PLANNING COMMISSION MEETING

b. Review SD-21-03 - 365 Cedar Road Final Major Subdivision Land Development plan.

RE: SD-21-03-365 Cedar Road (Yannessa Subdivision)
PARID: 30-00-07112-00-4 / TMID: 30086 020
Final Major Subdivision and Land Development Plans
Executive Summary

RECORD PLAN OF SUBDIVISION
365 CEDAR ROAD
ABINGTON TOWNSHIP, MONTGOMERY COUNTY, PENNSYLVANIA
MADE FOR
PAUL YANNESSA

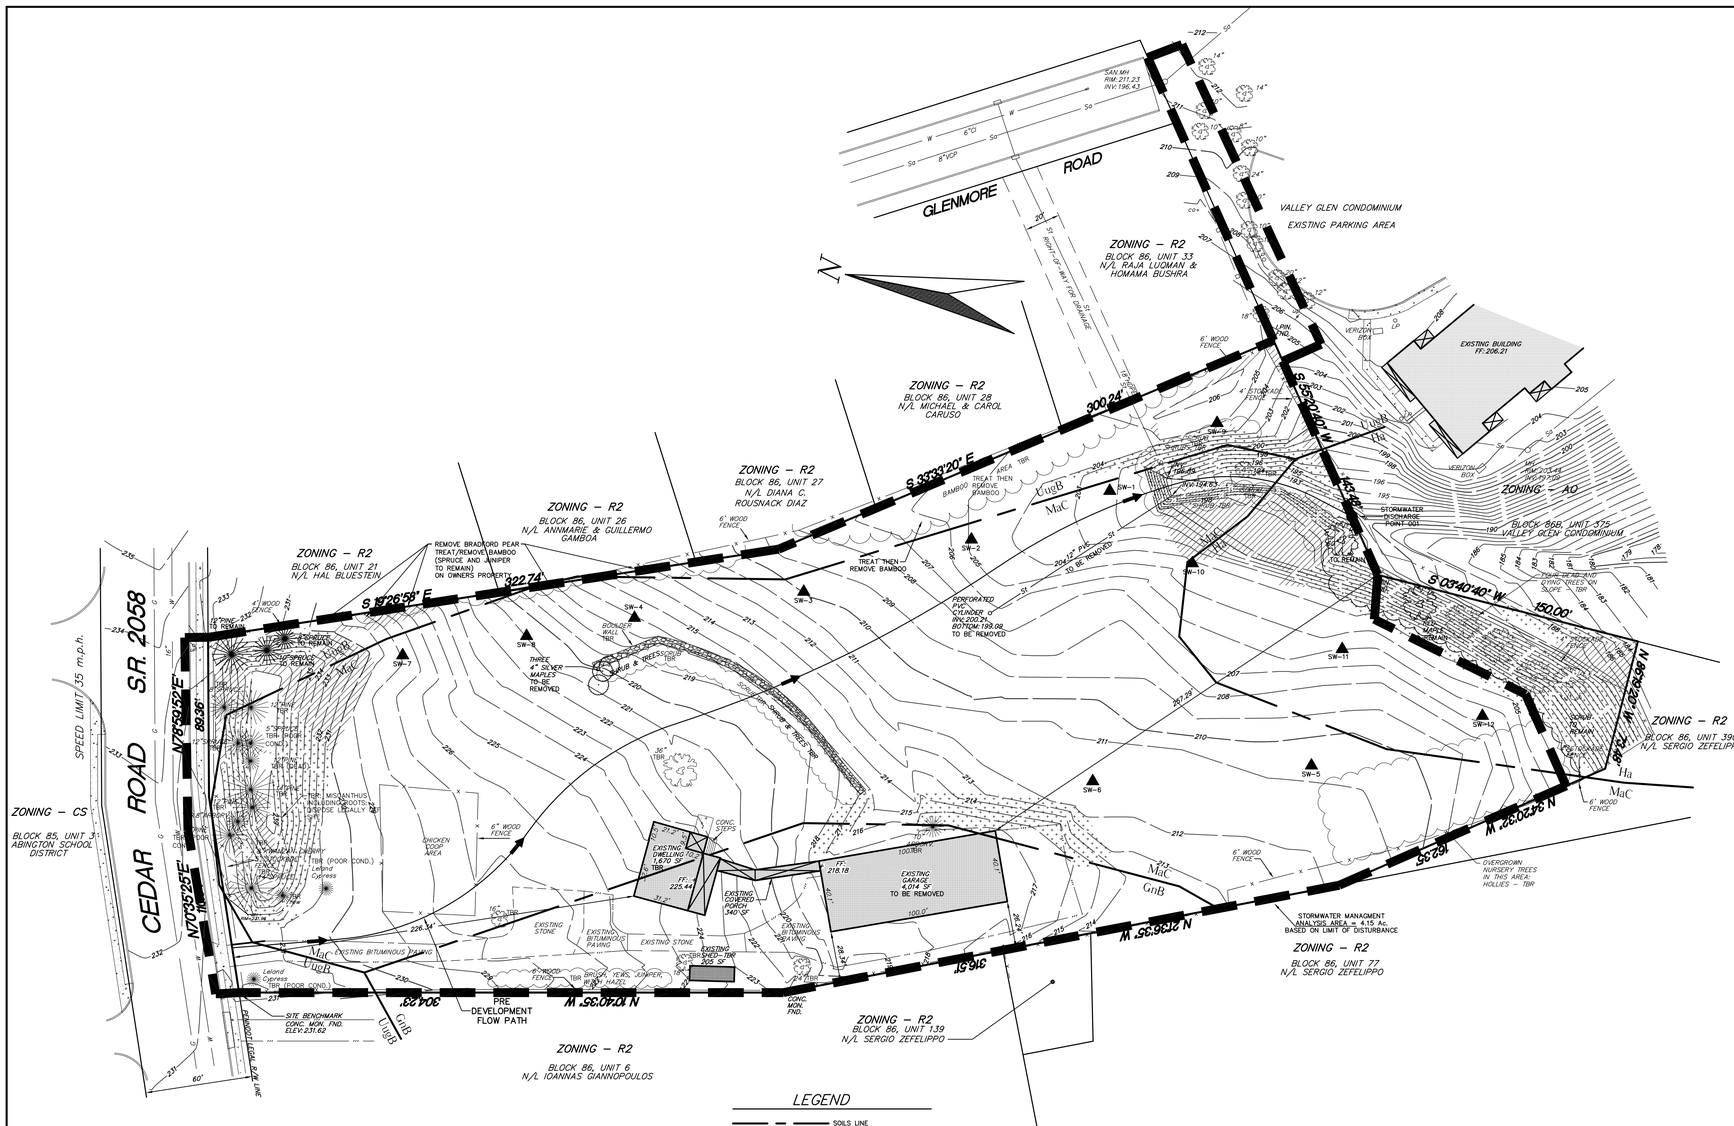
On the Record Plan (Sheet 1), the Permitted Dimensional Criteria Table is providing the 25% maximum building coverage for each lot and the Zoning data listed in Note 4 of the General Notes and Summary is still showing "less than 25%" building coverage being provided. A note was also provided under the Permitted Dimensional Criteria Table stating that the conceptual dwellings, driveways & walkways are shown on the plan, and the actual design & impervious coverage shall be based on final architectural plans & shall be provided on the individual building permit plans for review and approval. Based on our measurements and calculations of the proposed conceptual dwellings, we measured each conceptual dwelling size to be approximately 1,500 SF which will result in less than 10% of the building coverage for each lot which should comply with the required 25% maximum building coverage permitted for each lot; however the Applicant shall clarify and confirm by showing the square footage of each conceptual dwelling and building coverage on the plan for each lot to ensure compliance with this Code Section.

On the Record Plan (Sheet 1), the Permitted Dimensional Criteria Table is providing the 35% maximum impervious coverage for each lot and the Zoning data listed in Note 4 of the General Notes and Summary is still showing "less than 35%" impervious coverage being provided. A note was also provided under the Permitted Dimensional Criteria Table stating that the conceptual dwellings, driveways & walkways are shown on the plan, and the actual design & impervious coverage shall be based on final architectural plans & shall be provided on the individual building permit plans for review and approval. Based on our measurements and calculations of the proposed impervious areas, we measured the impervious coverage to range from approximately 2,200 SF to 2,581 SF which will result in approximately 8% to 10% of the impervious coverage for each lot which should comply with the required 35% maximum impervious coverage permitted for each lot; however, the Applicant shall clarify and confirm by showing the square footage of the impervious coverage on the plan for each lot to ensure compliance with this Code Section.

On the Record Plan (Sheet 1), the Permitted Dimensional Criteria Table is providing the 65% minimum green area for each lot and the Zoning data listed in Note 4 of the General Notes and Summary is still showing "more than 65%" green area being provided. Based on our measurements and calculations of the proposed impervious areas for each lot as noted above, the resulting green area for each lot ranging from at 84% to 92% should comply with the required 65% minimum green area for each lot; however, the Applicant shall clarify and confirm by showing the green area percentage on the plan for each lot to ensure compliance with this Code Section.

EROSION & SEDIMENT CONTROL PLAN DETAILS
365 CEDAR ROAD
ABINGTON TOWNSHIP, MONTGOMERY COUNTY, PENNSYLVANIA
MADE FOR
PAUL YANNESSA

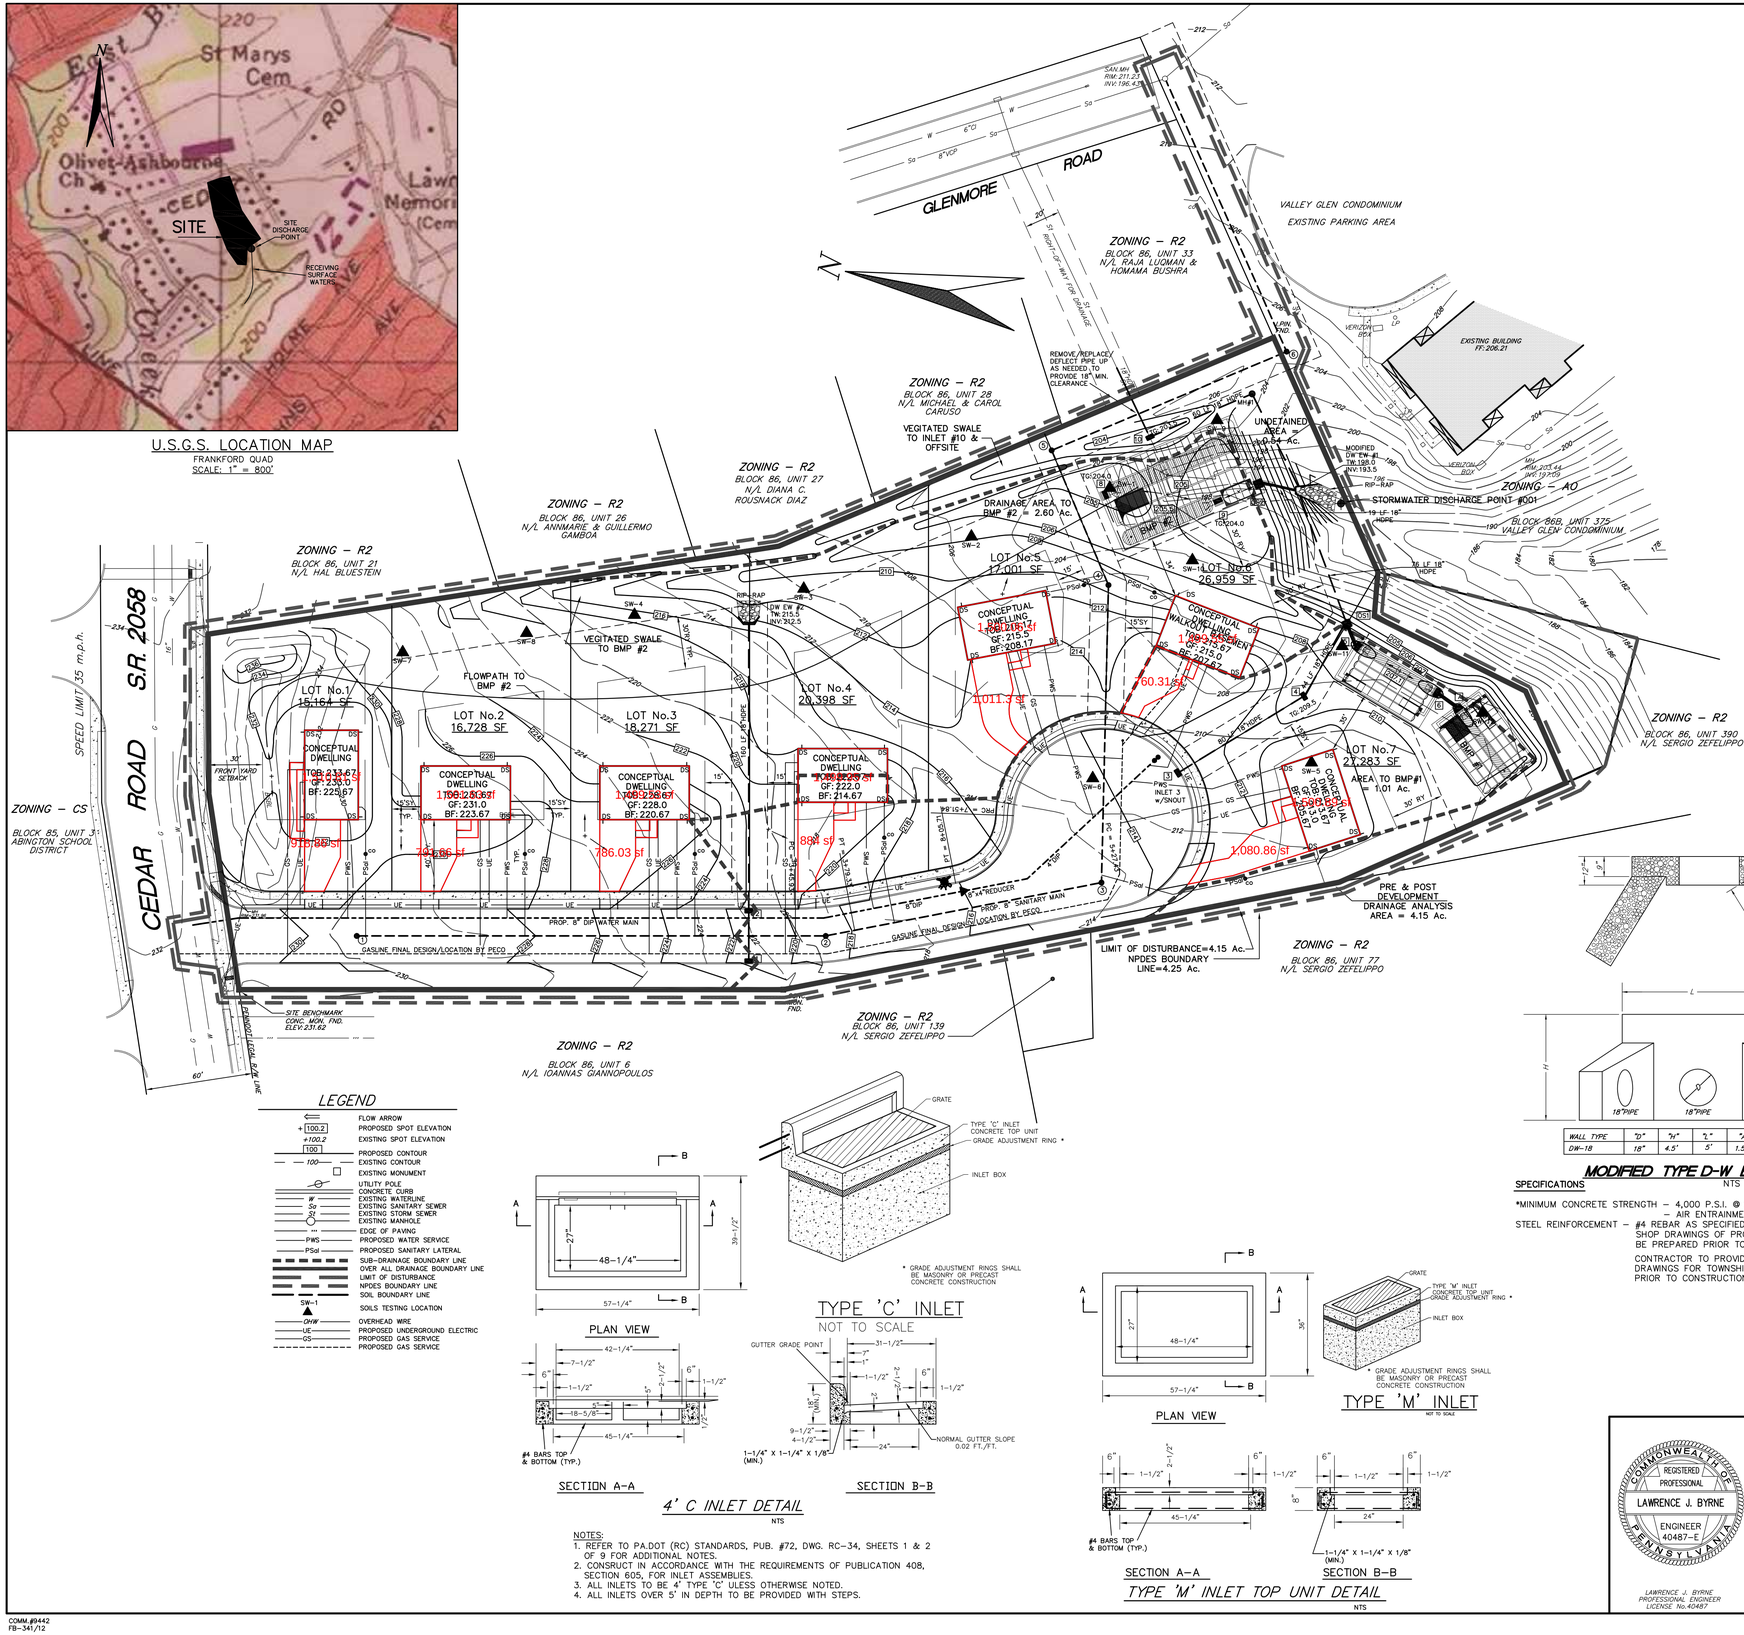
3. Please confirm that the permanent steep slope seeding mixture proposed in the Erosion and Sediment Control Detail notes on Sheet 6 is equivalent to utilizing steep slope seed mixes containing native species (Such as: ERNMX -181 (Native Steep Slope Mix w/Annual Ryegrass), which help stabilize the landscape and reduce runoff and sedimentation.

POST CONSTRUCTION STORMWATER MANAGEMENT PLAN
365 CEDAR ROAD
ABINGTON TOWNSHIP, MONTGOMERY COUNTY, PENNSYLVANIA
MADE FOR
PAUL YANNESSA

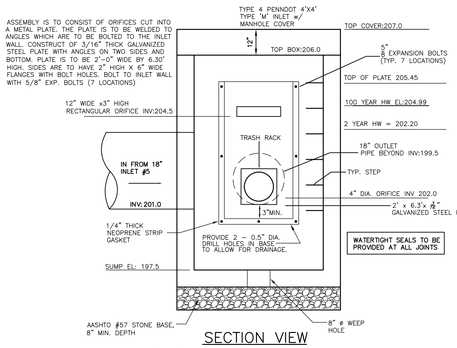
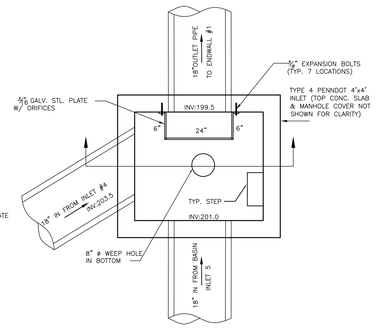
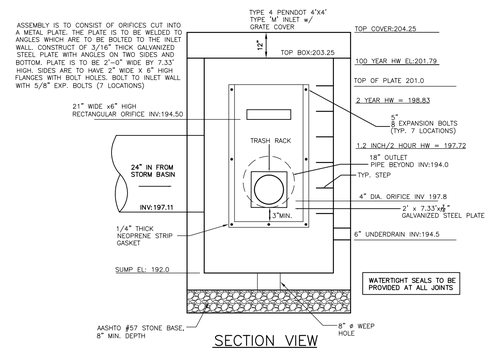
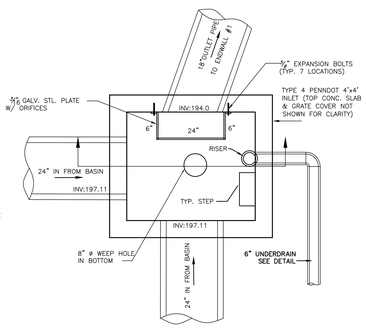
The municipal engineer certification block on the PCSM Plan (Sheet 7) shall reference Municipal Ordinance no. 2100 instead of Chapter 142.

33. *The Raingarden Section Detail on Sheet 7 shall provide the 100-year storm water elevation which is currently not shown on the detail provided.*
